TECHNISCHE INFORMATION NR. SI 36-126

SERVICE INFORMATION NO. SI 36-126

BRP-Rotax GmbH & Co KG Service Bulletin SB-912-078 / SB-914-059

Exchange of propeller shaft on ROTAX® Engine type 912 / 914 (Series) and 912 i (Series)

Fig. 1

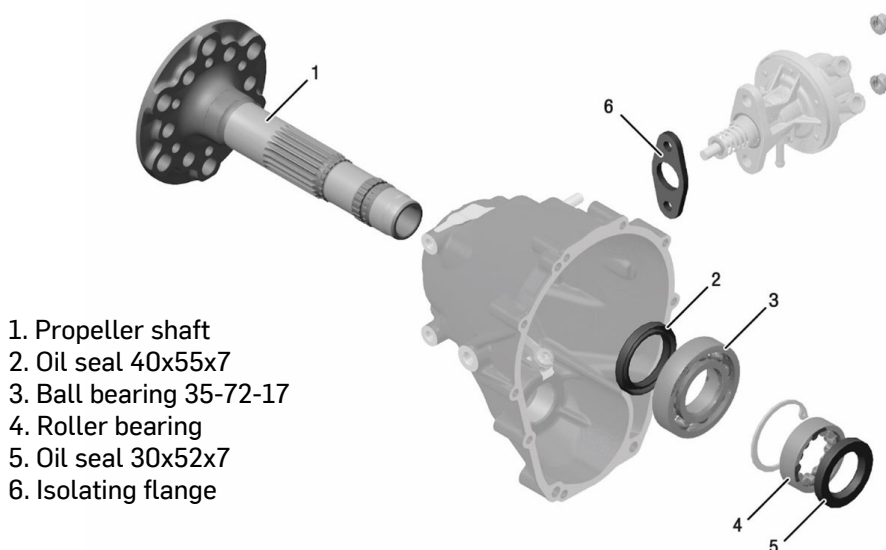
See Fig. 1.

Parts requirement in case of replacement:

| Part no. | Qty/engine | Description | Application |
|----------|------------|-----------------------|------------------------|
| 937047 | 1 | Propeller shaft | Version 2 |
| 832587 | 1 | Ball bearing 35-72-17 | Gearbox side |
| 950470 | 1 | Oil seal 40x55x7 | Gearbox side |
| 232246 | 1 | Roller bearing | Crankcase side |
| 950200 | 1 | Oil seal 30x52x7 | Crankcase side |
| 950228 | 1 | Isolating flange | Fuel pump (912 Series) |
